**Re: PETITION NO. 1599 – TRITEC Americas, LLC notice of election to waive exclusion from Connecticut Siting Council jurisdiction, pursuant to Connecticut General Statutes §16-50k(e), and petition for a declaratory ruling, pursuant to Connecticut General Statutes §4-176 and §16-50k, for the proposed construction, maintenance and operation of a 0.999-megawatt AC solar photovoltaic electric generating facility located at Parcel No. 30-25-59 Spencer Street, Suffield, Connecticut, and associated electrical interconnection. **Petitioner Responses to Interrogatories from Council.****

**Petition No. 1599  
TRITEC Americas, LLC  
Parcel No. 30-25-59  
Spencer Street, Suffield, Connecticut**

**Interrogatories  
February 7, 2024**

Sheet Title:	SITE LAYOUT PLAN
Sheet #:	2.11

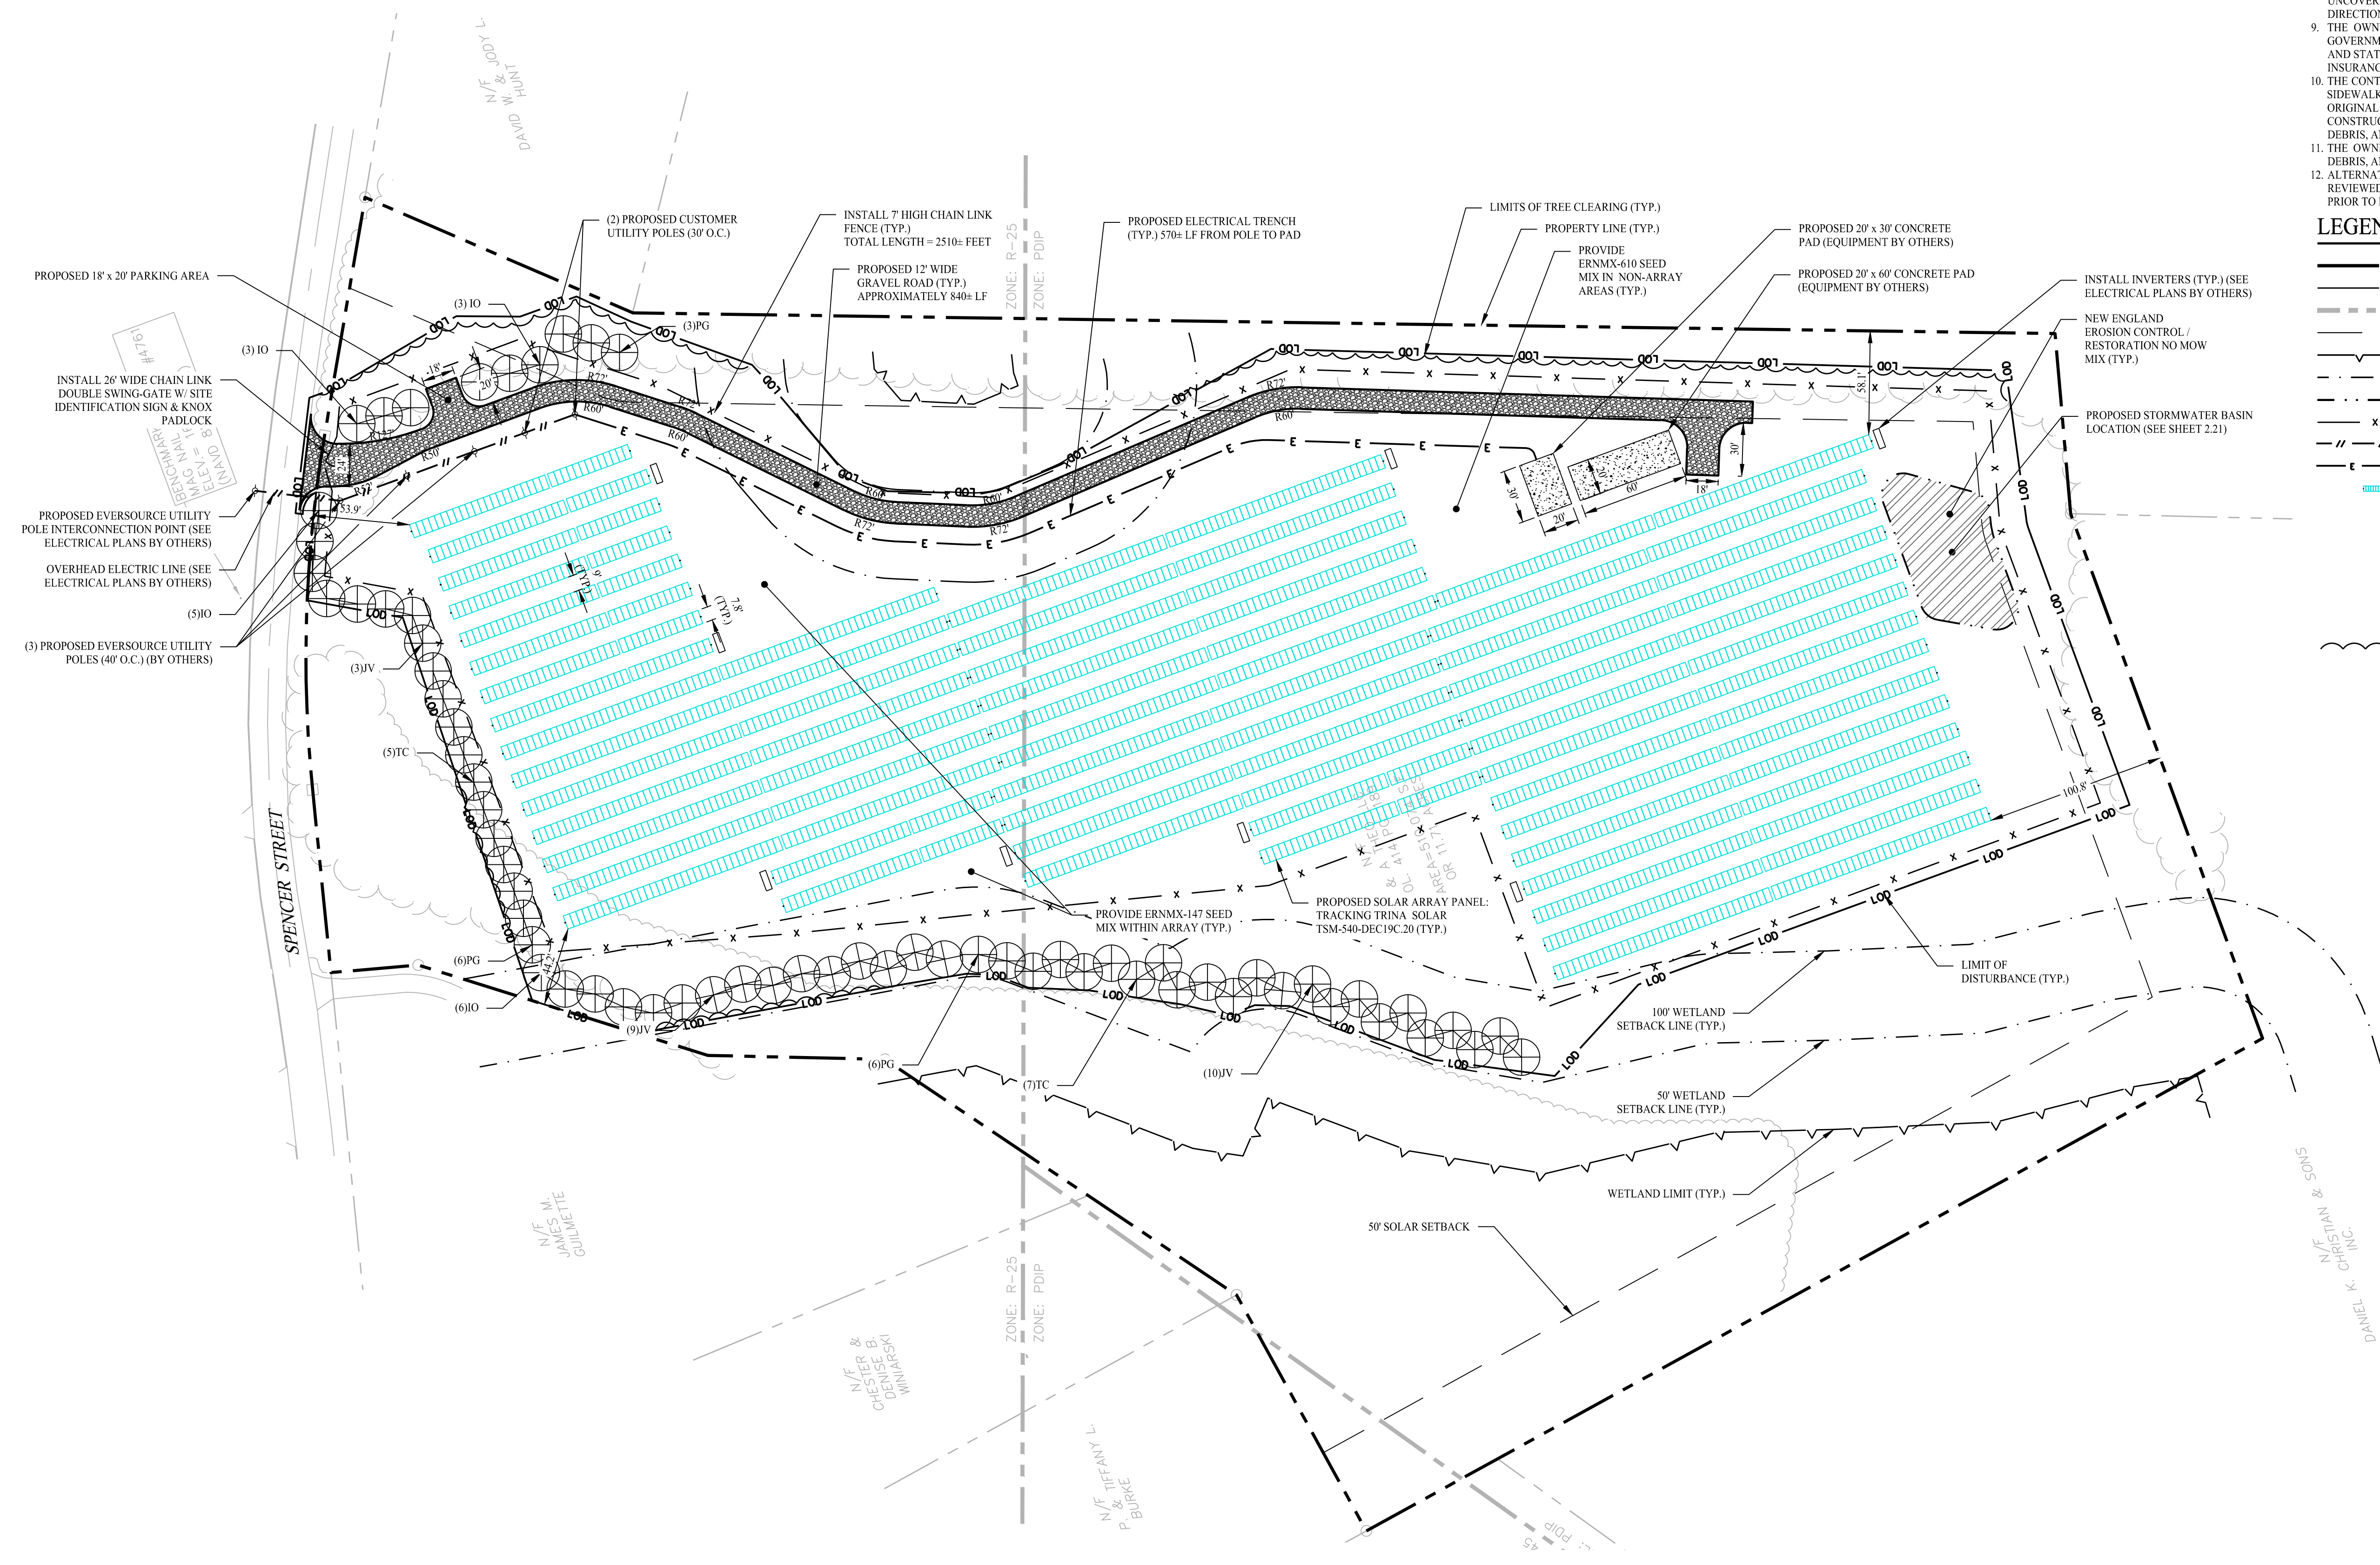
28. Referencing Petition Site Plans 2.11, four proposed utility poles are shown; however, three poles are listed in Petition Appendix G, p. 4. Clarify.

30. Referencing Petition Site Plan 2.11, why do the utility poles need to be within 10 feet of each other? Can some or all the utility poles be located farther to the south and west of the access road parking area?

**RESPONSE: The Site Plan has been modified to show five (5) utility poles: three (3) Eversource-owned poles and two (2) customer-owned poles. Ultimately Eversource will dictate the exact details of the interconnection as it pertains to quantity and spacing of the poles, however the proposed alignment is based on recent projects of similar size. Please see, "Site Layout Plan 2.11."**

**RESPONSE: The Site Plan has been modified to provide 40-foot spacing between the (3) Eversource-owned utility poles and 30-foot spacing between the (2) customer-owned poles. The poles are placed along the proposed access drive. Ultimately Eversource will dictate the exact details of the interconnection as it pertains to quantity and spacing of poles, however the proposed alignment is based on recent projects of similar size. Enclosed, please see, "Site Layout Plan 2.11."**

7' HIGH CHAIN LINK FENCE DETAIL

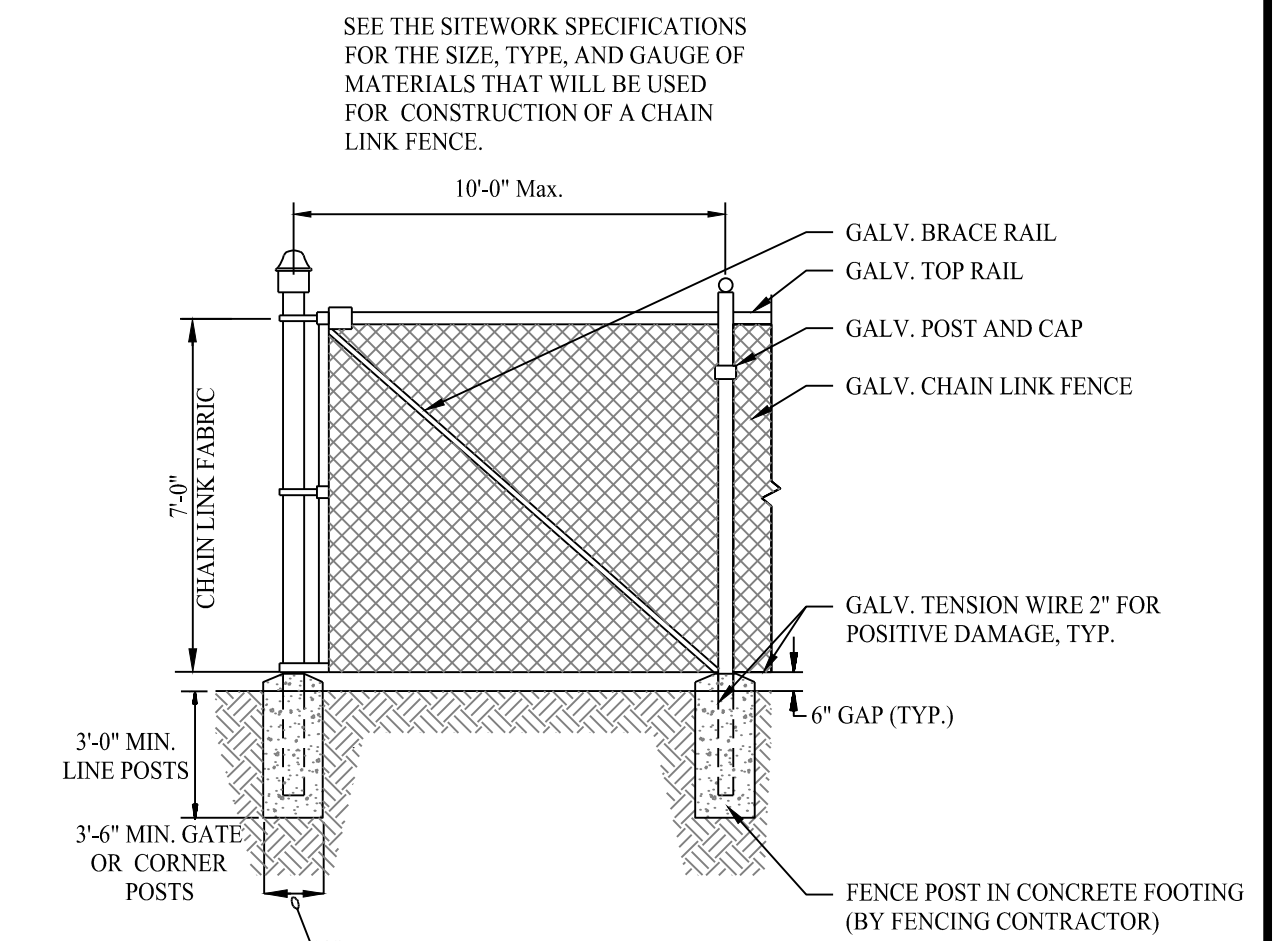
41. Referencing Petition Site Plan 3.01- Fence Detail, and Petition Exhibit G, p. 8, can the bottom of the perimeter fence fabric be raised to a height of six-inches above grade to allow for small wildlife movement?

**RESPONSE: The proposed fence detail has been modified accordingly. Please see “Details Sheet 3.01.”**
